ADDENDUM

**EXPANDED PURE WATER MONTEREY/GROUNDWATER
REPLENISHMENT PROJECT**

SUPPLEMENTAL ENVIRONMENTAL IMPACT REPORT
STATE CLEARINGHOUSE NO. 2013051094

DEEP INJECTION WELL #6 CHANGES

Changes Since Certification of SEIR

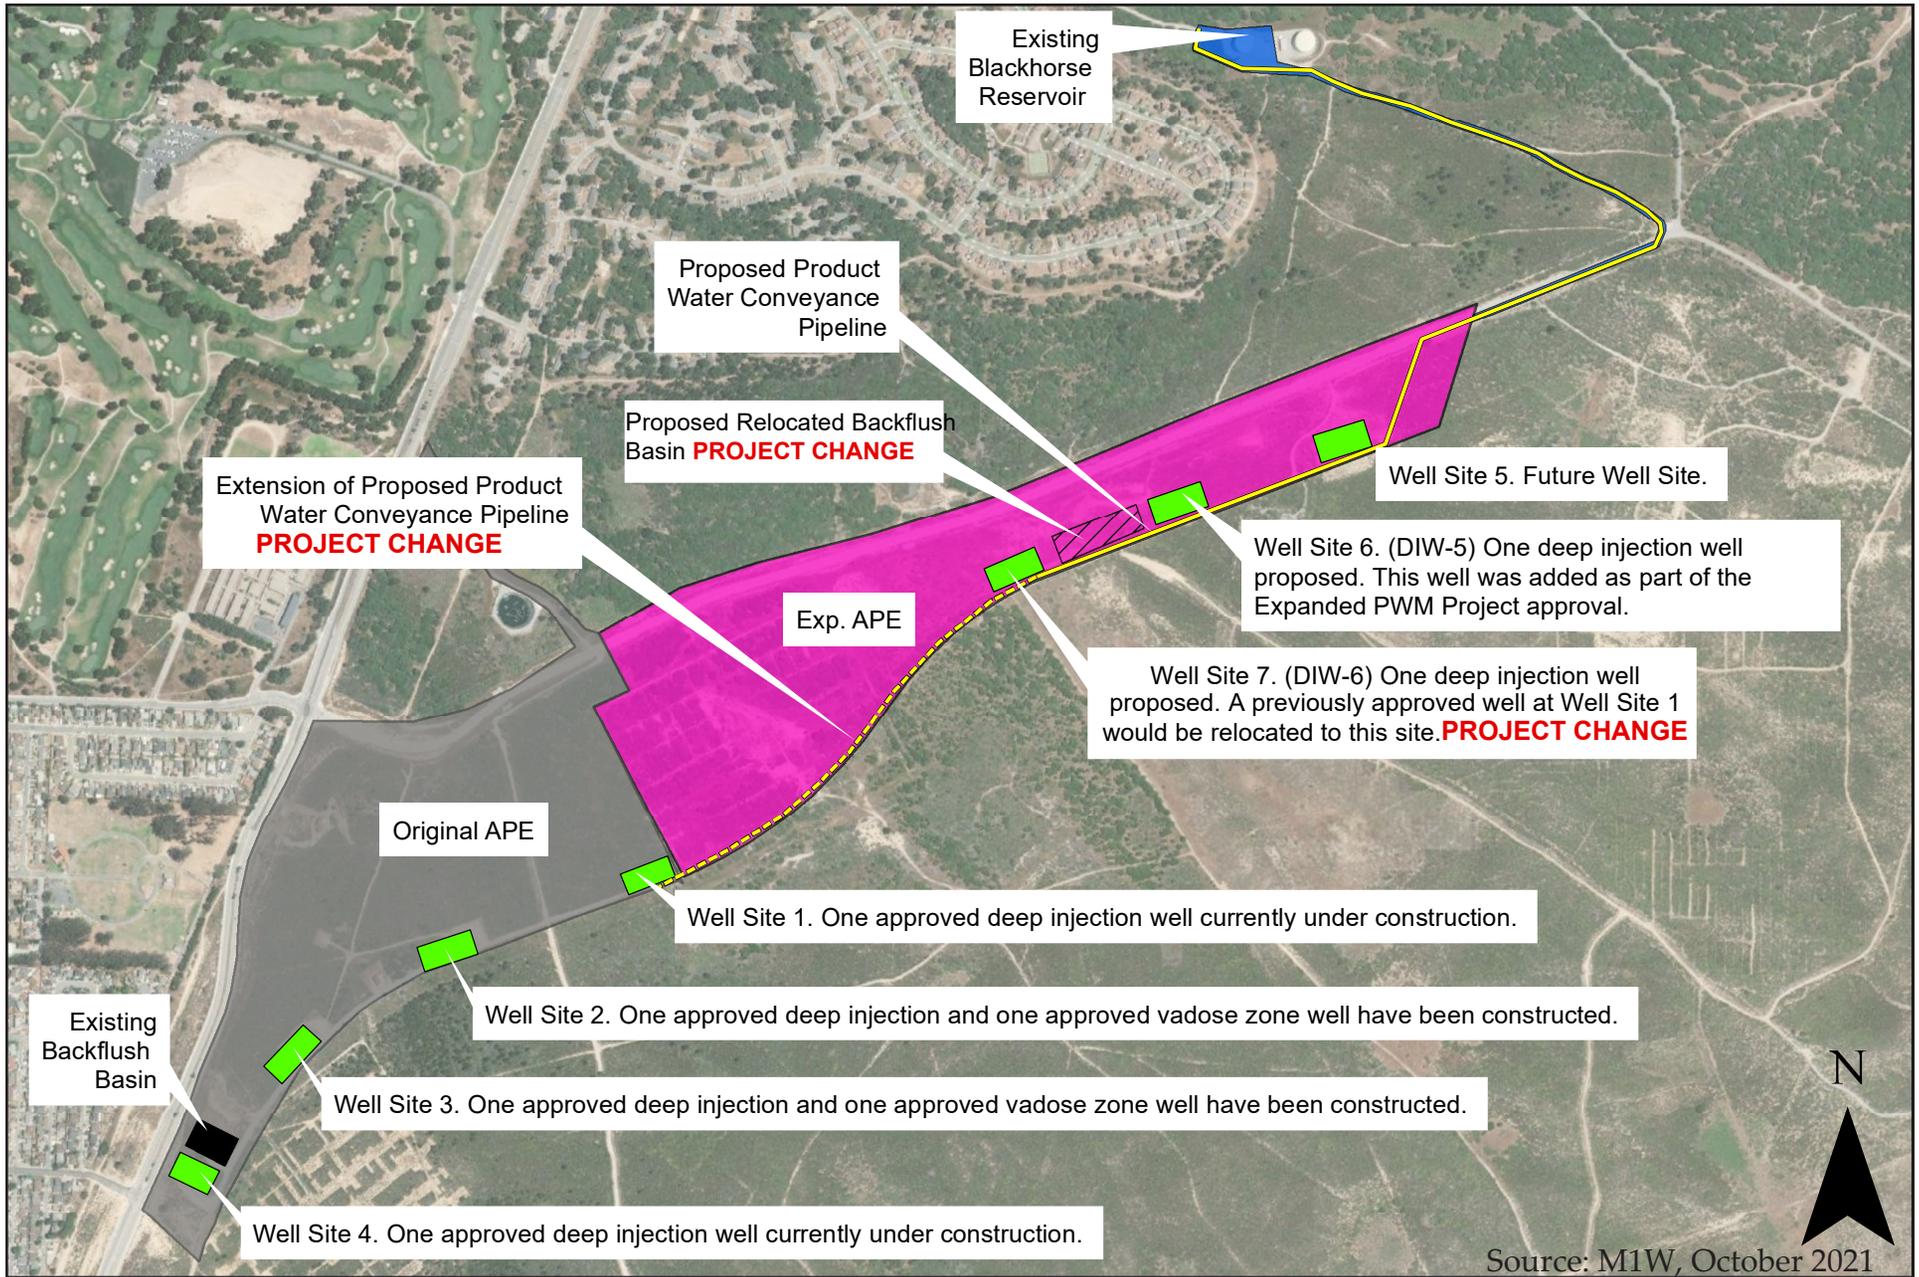
The proposed changes referenced as “Deep Injection Well #6 Changes” evaluated in this Addendum include the following as shown in **Figure 3. Changes Since Certification of SEIR**, below:

1. *Relocation of an Approved Injection Well from Well Site #1 to Well Site #7*: The vadose (shallow) zone well previously approved as part of the base project at Well Site #1 would be relocated to Well Site #7 as a deep injection well, referred to as Deep Injection Well #6. This change would result in two (2) proposed deep injection wells within the Expanded Injection Well Area rather than just one. This change does not increase the number of approved wells; the total number will remain nine (9). The depth of the well would increase from 600 to 1,100 feet below ground surface.

- 3) *Relocation of Approved Backflush Basin*: The entire Injection Well Facilities Area was evaluated in the 2021 Certified SEIR. The relocation of the backflush basin from between Well Site #5 and #6 to between Well Sites #6 and #7 would not change the boundary of the area previously evaluated.
